Woolf Bond Planning

OUTLINE PLANNING APPLICATION (WITH ACCESS TO BE DETERMINED) - Application Number 2025/245

Land South of Barrow Green Road, Oxted

Figure 1 Excerpt of Motion's Drainage Strategy

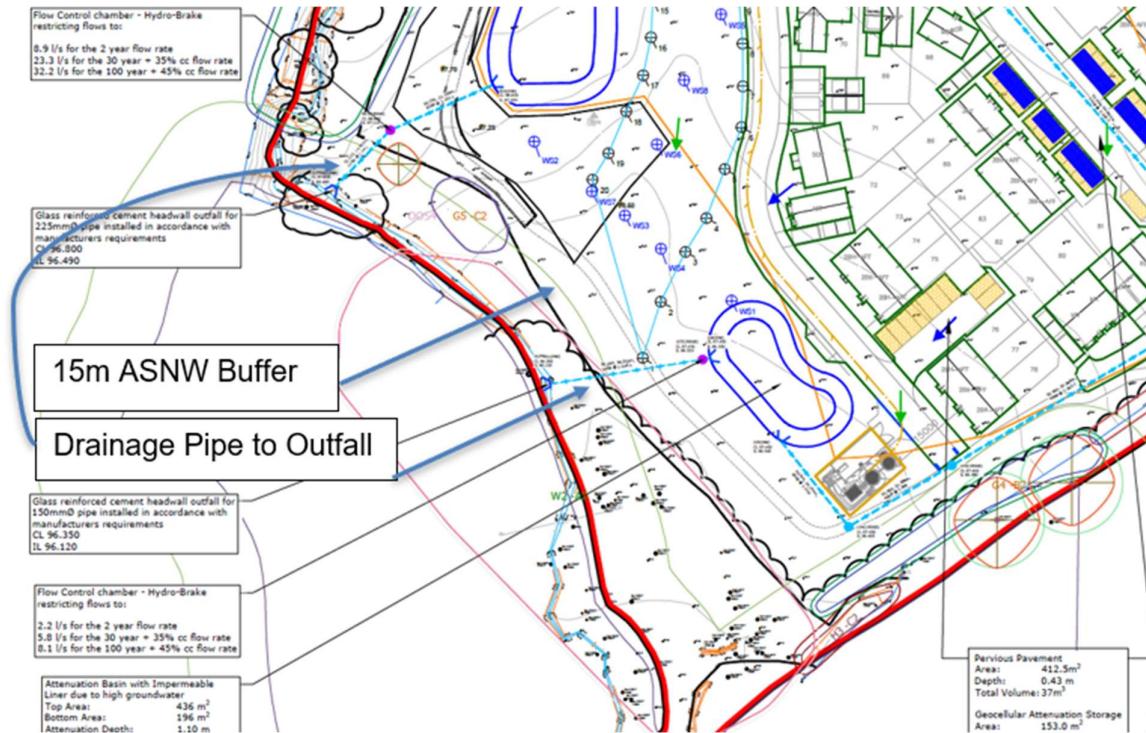
The Technical Note is also accompanied by an updated Drainage Strategy drawing (Appendix B to the Technical Note) which details the drainage strategy. That Updated Drainage Strategy drawing provides the clarification sought by Council officers as to the position of the stream within the Site boundary and the parts of stream where works to discharge surface water will be located within the Site. It also now shows the 15m ASNW buffer line marked green). The drainage outfalls will be located wholly within the Site boundary, to allow for ongoing management and maintenance.

Figure 1, below, is a marked up excerpt of that drawing, to aid the Council in identifying that the drainage strategy involves drainage outfalls *within* the Site boundary, which are *within* the ASNW 15m buffer (but *beyond* the ASNW itself).

Figure 2 Excerpt of Illustrative Landscape Strategy Plan

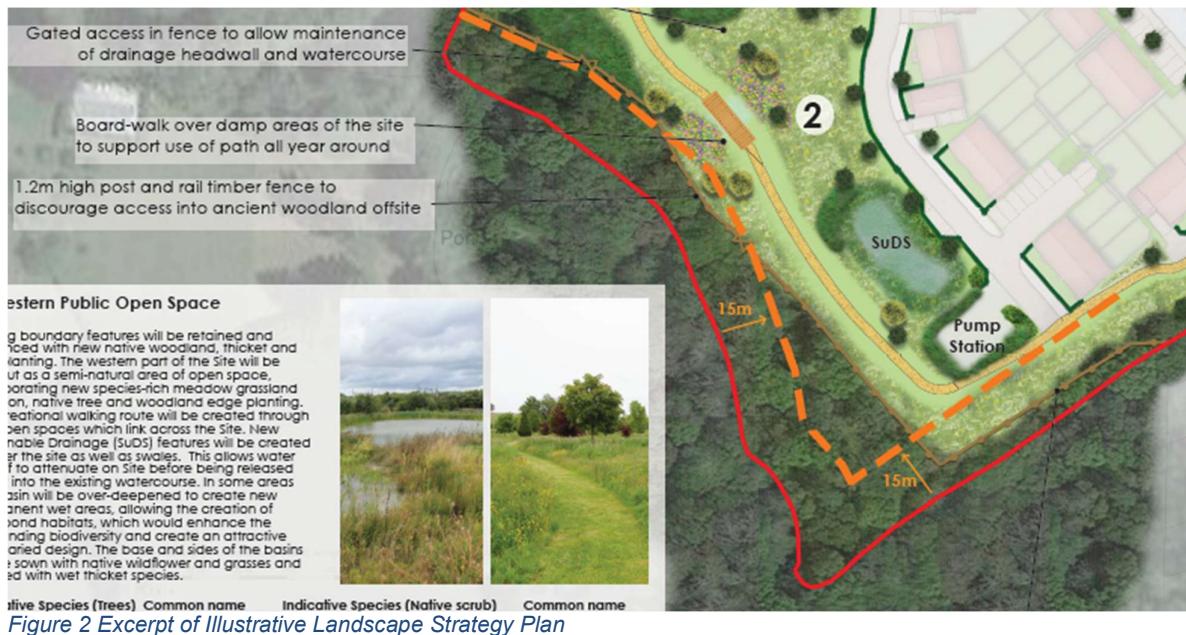
As shown on the Illustrative Landscape Strategy Plan no development is proposed within 15m of the ASNW boundary. The drainage attenuation basins, roads and development plots (shown for illustrative purposes on the Illustrative Masterplan) are all located beyond the 15m buffer. This is compliant with the Government's Ancient Woodland Guidance¹.

Figure 2 below is an excerpt of the submitted Illustrative Landscape Strategy Plan showing the 15m buffer marked in orange. This plan is annotated to show that a 1.2m high fence will be erected along the edge of the (non ASNW) woodland within the Site to discourage recreational access/ disturbance.
